**SUBDIVISION,  
PLANNED UNIT DEVELOPMENT, &  
REZONING STAFF REPORT****Date: February 18, 2016**

| <b><u>SUBDIVISION NAME</u></b>                  | ASM Subdivision  |
| <b><u>CONTEMPLATED USE</u></b>                  | <p>Subdivision Approval to create one legal lot of record from six existing metes-and-bounds parcels; Planned Unit Development to allow multiple buildings on a single building site; and Rezoning from I-1, Light Industry District, and B-2, Neighborhood Business District, to I-1, Light Industry District, to allow a recycling center and eliminate split zoning.</p> <p><b>It should be noted, however, that any use permitted in the proposed district would be allowed at this location if the zoning is changed. Furthermore, the Planning Commission may consider zoning classifications other than that sought by the applicant for this property.</b></p> |

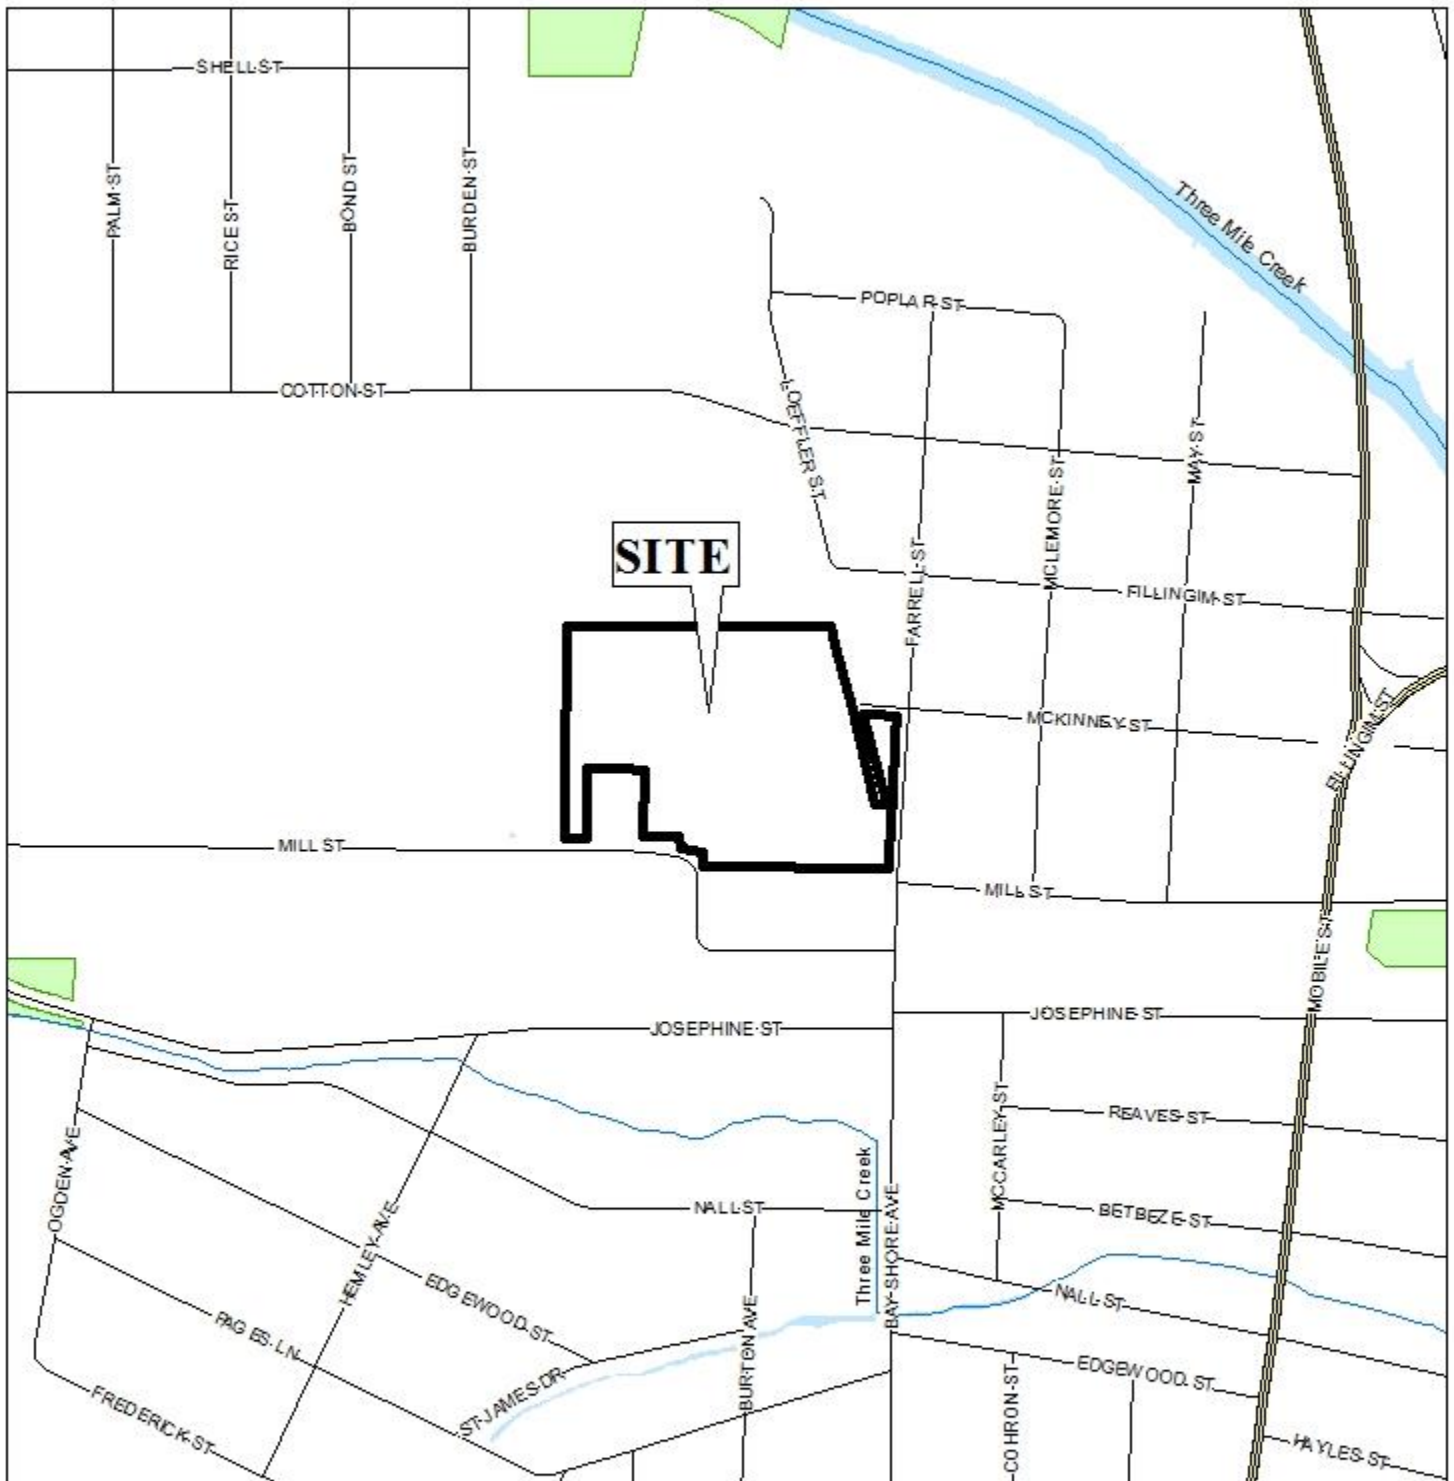
- A. Provide all of the required information on the SUBDIVISION PLAT (i.e. signature blocks, signatures, certification statements, written legal description, required notes, legend, scale, bearings and distances) that is required by the current Alabama State Board of Licensure for Professional Engineers and Land Surveyors.

- B. Show and label the proposed lot boundary. Show internal lines with a different line type and thickness.
- C. Provide a written legal description for the proposed subdivision and matching bearing and distance labels. The labeled LOT 1 is located outside of the area contained in the written legal description.

- D. Show and label each and every Right-Of-Way (Loeffler St.) and ROW Vacation (Loeffler St ROW (1978).
- E. Provide the Surveyor's, Owner's (notarized), Planning Commission, and Traffic Engineering signatures.

# SITE PLAN

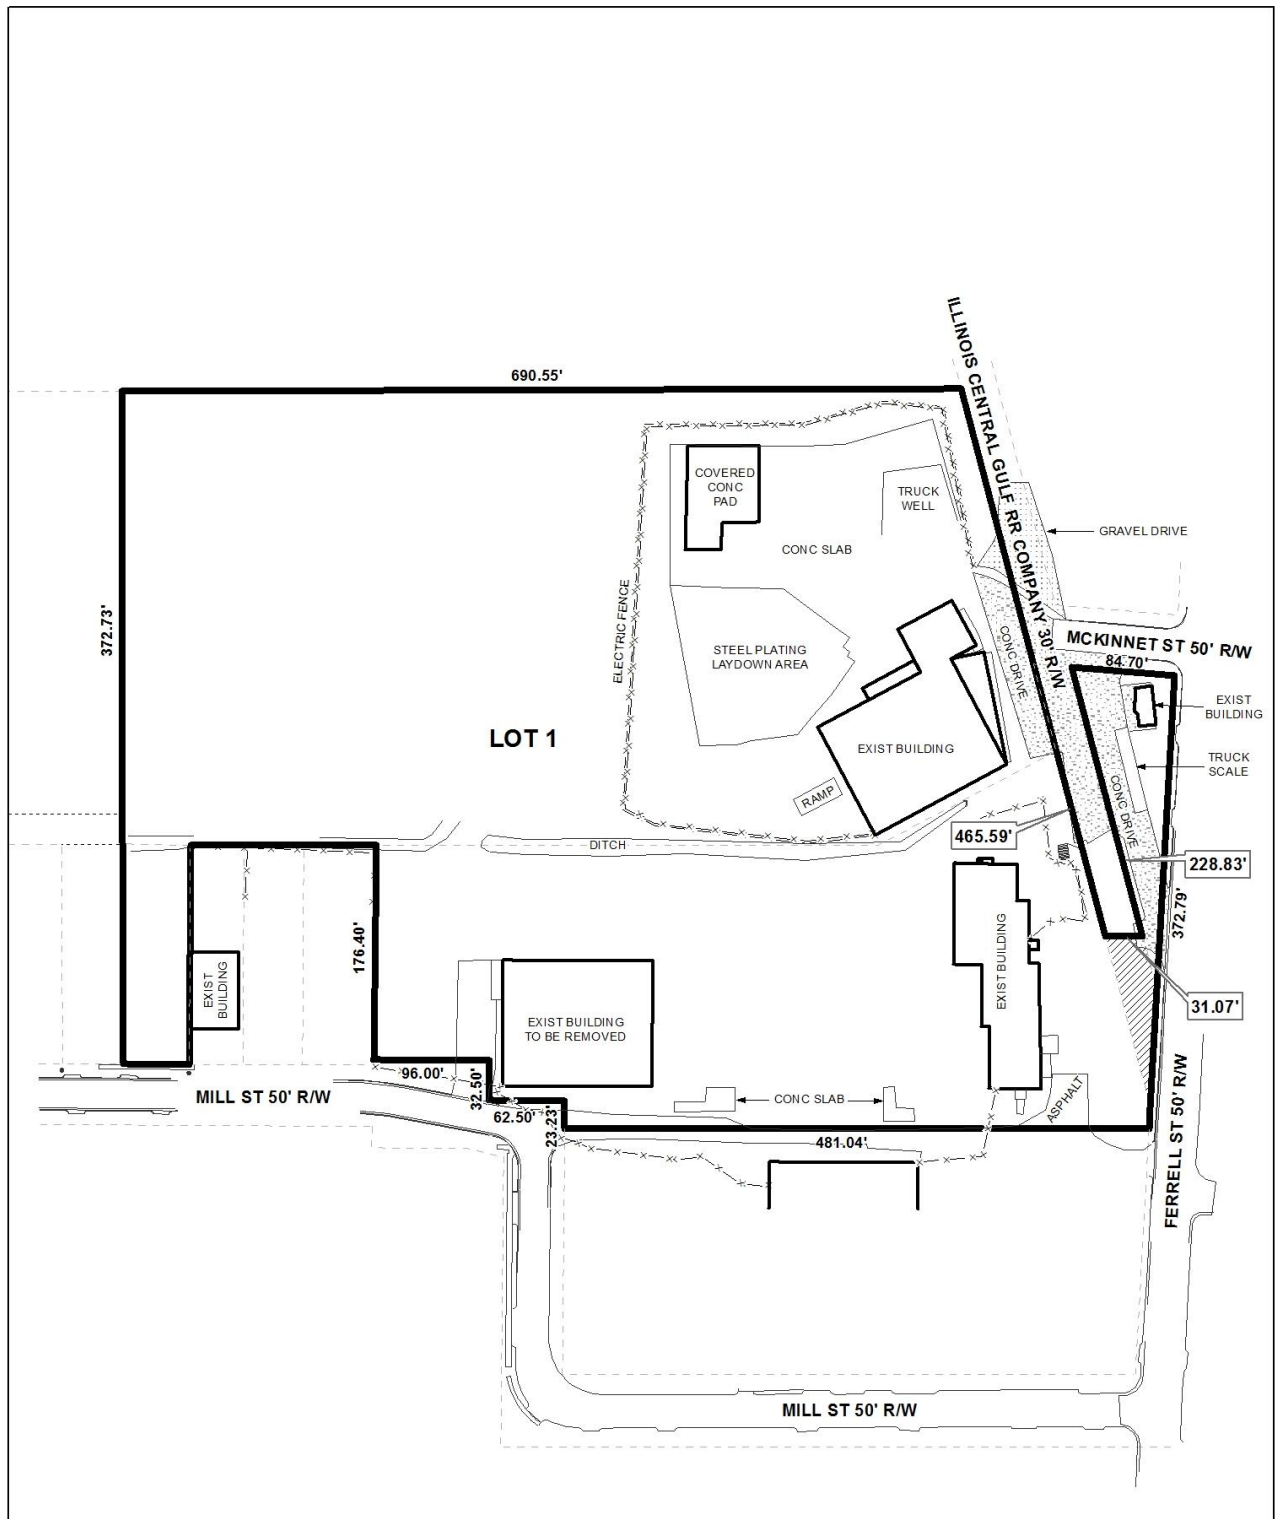
The proposed lot has frontages on Mill Street, Ferrell Street and McKinney Street, all minor streets with compliant 50' rights-of-way along the site; therefore, no dedication would be required. As a means of access management, and since the lot would have over 200' of combined street frontage, a note should be required on the Final Plat stating that the lot is limited to one curb cut each to McKinney Street, Ferrell Street, and Mill Street, with size, location and design to be approved by Traffic Engineering and conform to AASHTO standards. The 25-foot building setback line is shown along most street frontages, but not where the Western portion of the site extends to Mill Street. Therefore, the plat should be revised to also indicate the 25' minimum building setback line at this location.

The site currently shares access with the property to the South via a cross-access drive near the East side and a shared access from Mill Street along the West side. As the PUD is not intended for these to be shared, both drives should be physically blocked prior to signing the Final Plat for the Subdivision.

With regard to the PUD, the site plan indicates a non-compliant site in that there are numerous access points with substandard access/maneuvering areas, no designated parking, no landscaping or tree planting, no dumpster, and no sidewalks. Parking calculations are provided but no parking is indicated. Landscaping and tree planting calculations are provided but no tree plantings are indicated. It should be noted that the remnants of a once-larger building are indicated on the Southern portion of the site and a demolition permit was issued for its removal during the course of this review. The major portion of this building was removed via a demolition permit in 2013.

No narrative was provided for the PUD to describe the intended use for the expanded site and no improvements are indicated on the site plan for future use. The applicant has used the Northern portion for a non-ferrous metal recycling center since 2006 and the Southern portion has had concurrent mixed uses with the last being a towing service until 2013 and a self-storage facility until 2014. It appears to be currently vacant. As insufficient information has been provided to conduct a thorough review of the application relative to its proposed use and possible improvements, staff feels that it should be heldover to the March 17<sup>th</sup> meeting to allow the applicant to provide a detailed narrative for the PUD as to the use of the over-all site. The site plan should also be revised to indicate possible improvements, compliant access/maneuvering area, compliant parking, compliant frontage tree planting, dumpster(s), and public sidewalk

- 1) submission of a narrative describing the proposed use of the over-all site and any intended improvements;
- 2) revision of the site plan to indicate possible improvements;
- 3) revision of the site plan to indicate compliant access/maneuvering areas;
- 4) revision of the site plan to provide compliant parking (including any required accessible parking);
- 5) revision of the site plan to provide compliant frontage tree planting;
- 6) revision of the site plan to provide compliant dumpsters; and
- 7) revision of the site plan to provide a public sidewalk along all street frontages.
